**Summary Updates for Decommissioning Risk Study
and Comments on NEI Review**

Structural Integrity of Spent Fuel Pool Structures Subject to Heavy Loads Drops

Figure 4 - Tornado risk regionalization scheme (from NUREG/CR-2944)

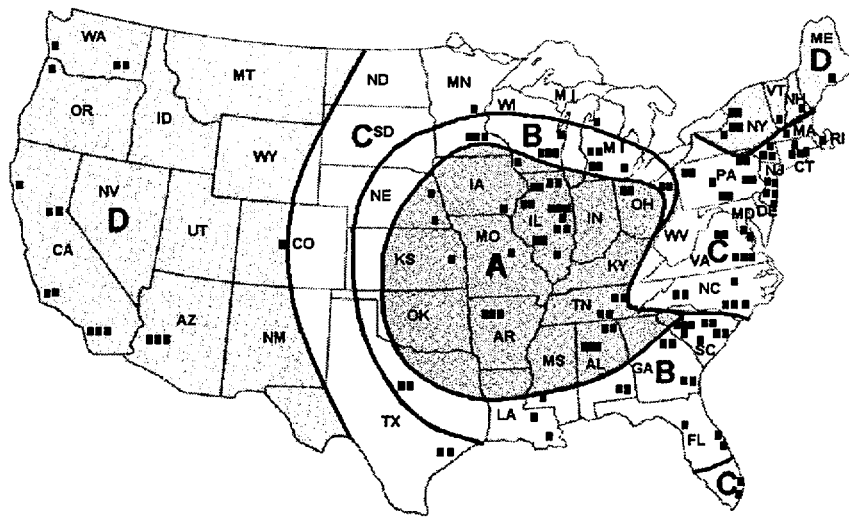
NEI is correct in that the value presented was for the highest tornado region. The exceedance values are best estimate. Because of the rush to release the report, some last minute changes did not get into the draft as released, and **5.6×10^{-7} per year (exceeding an F4) is the correct value.** It is appropriate to use a regionalization even if a region (state) has no sites. For example, if Oklahoma is not considered, the value drops to 5.4×10^{-7} per year.

The revised report will include the following table and figure to show the regional variations:
